FLOODING OF THE GENERAL MANAGER'S "FINELY TUNED" MONA VALE POST OFFICE CAR PARK

Extensive flooding occurs in the Mona Vale Post Office Car Park in Bungan Lane, when it rains, which is a regular occurrence in Mona Vale ! This results in not just wet concrete but flowing floodwaters through the car park, creating "unsafe situations" for the public walking through the car park.

1) The smooth finished car park areas

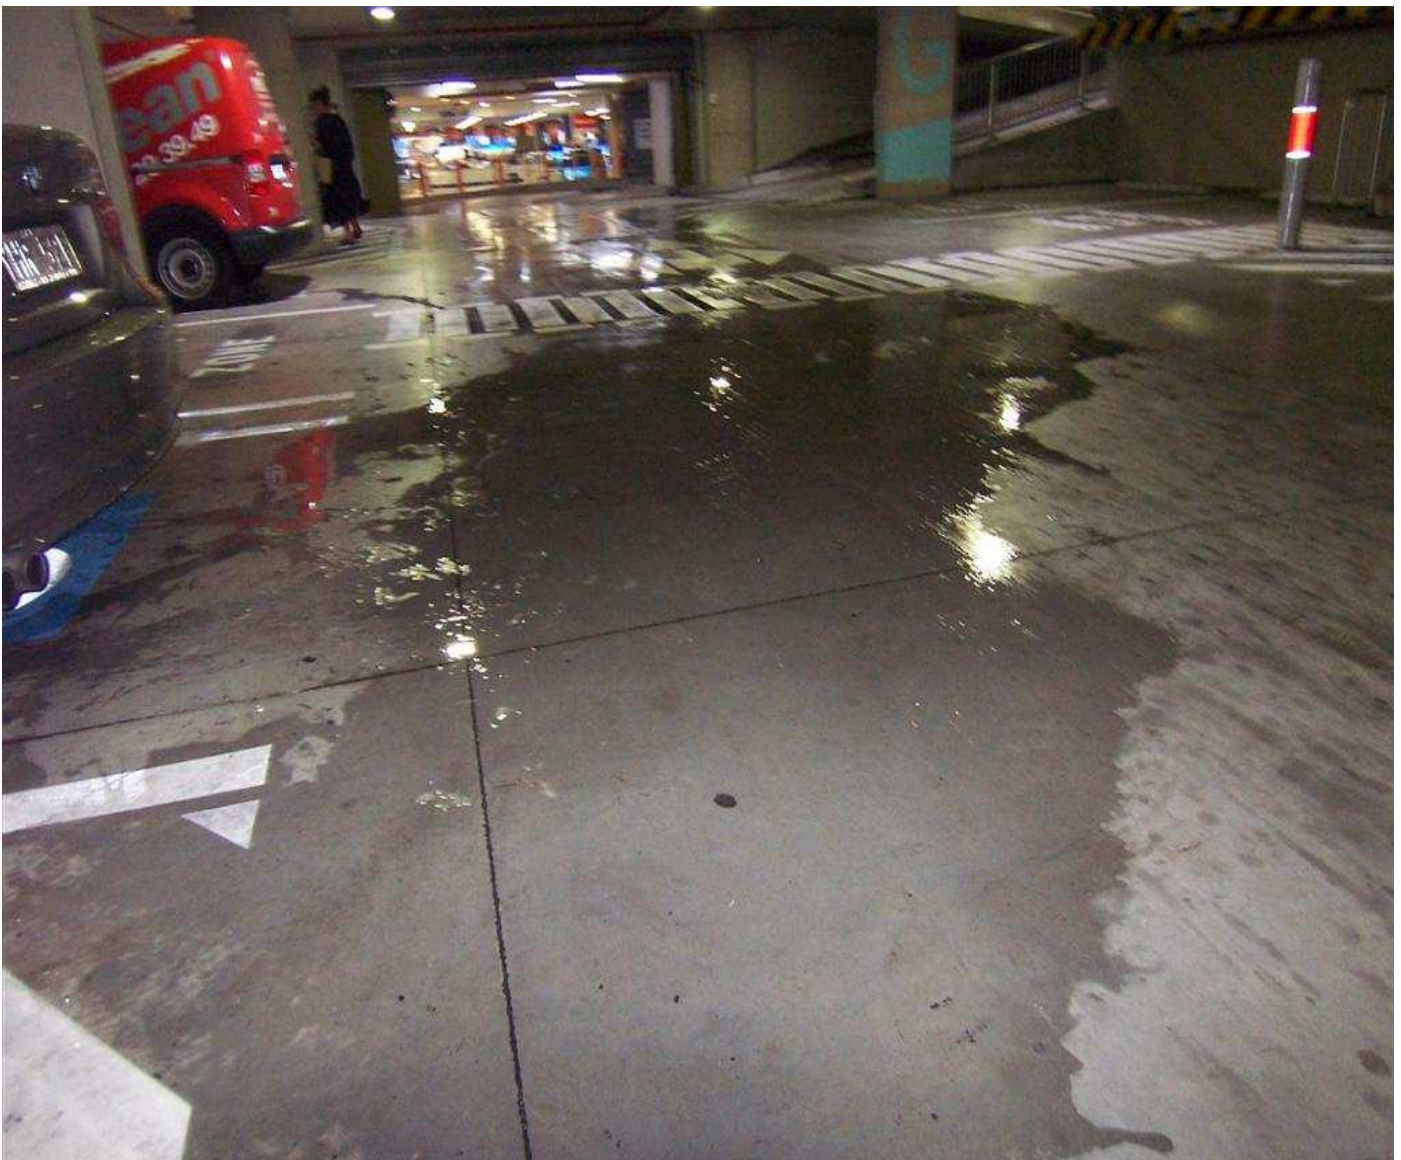
The car park floors have been constructed with a smooth steel trowel finish which when covered with water creates a dangerous situation for slipping, similar to trying to walk on an “ice skate rink”.

The photo below shows the regular puddle where one of our committee members slipped with both feet on this smooth finish level concrete resulting in a back injury.

3) The Disabled Access Ramp.

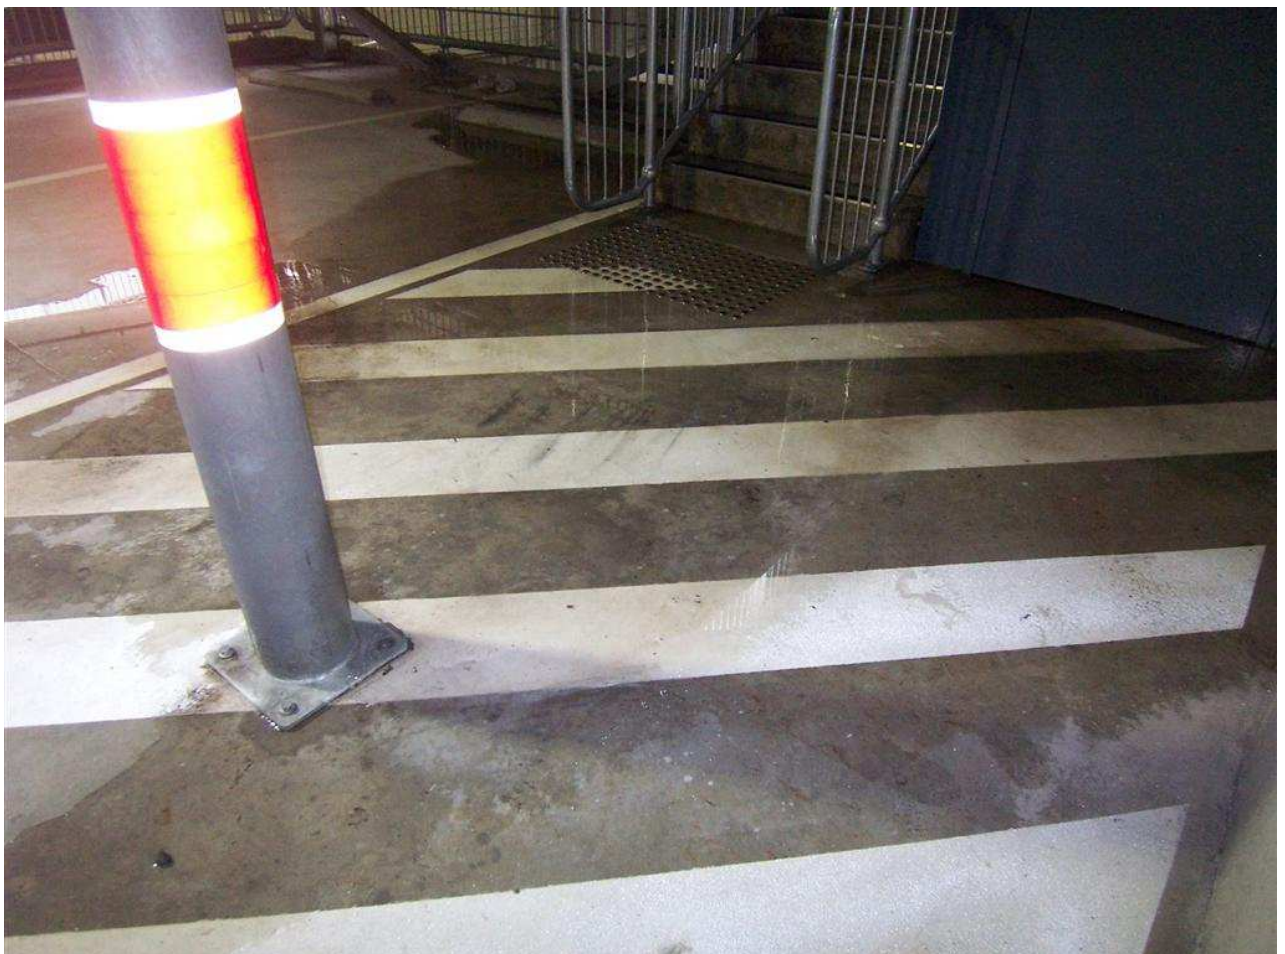
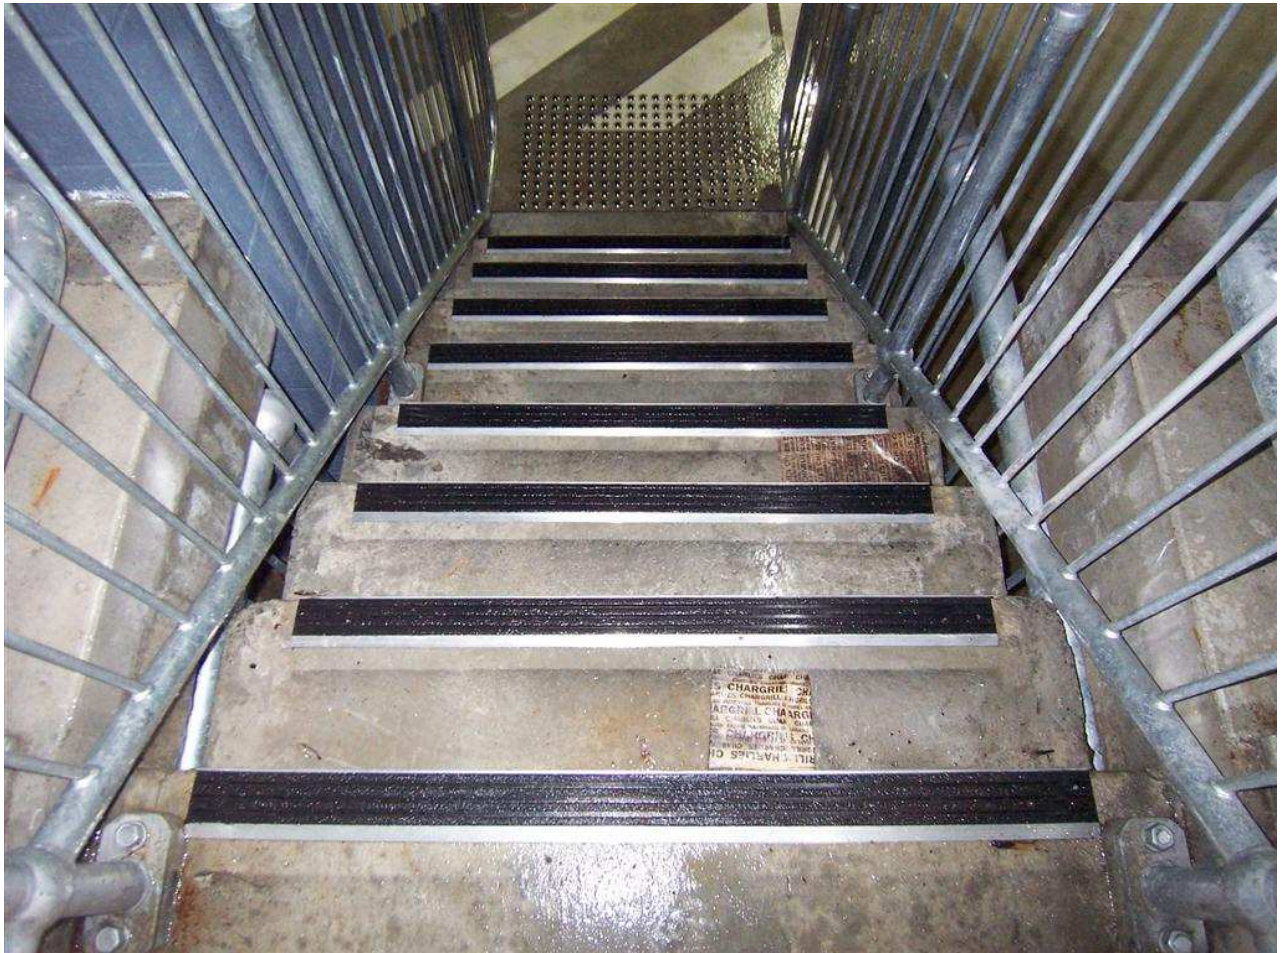
The main pedestrian exit / entry ramp to the lower ground level is extensively flooded whenever it rains

4) The Internal Stairs

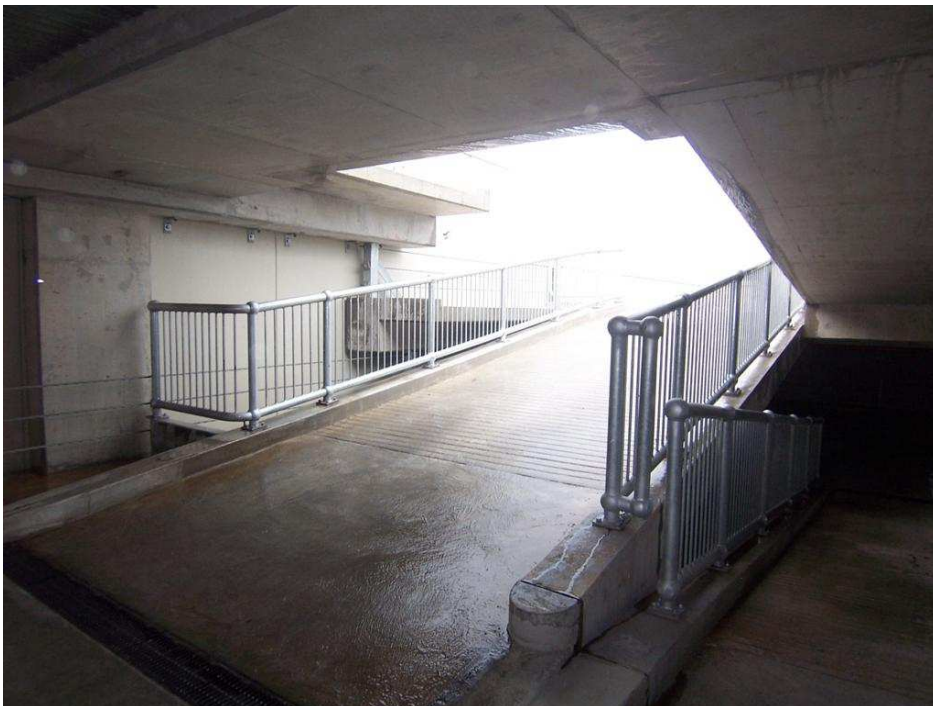
Water floods into the car park from the roof top level

This results in the “*unsafe situation*” of steps on each level of the car park being wet.
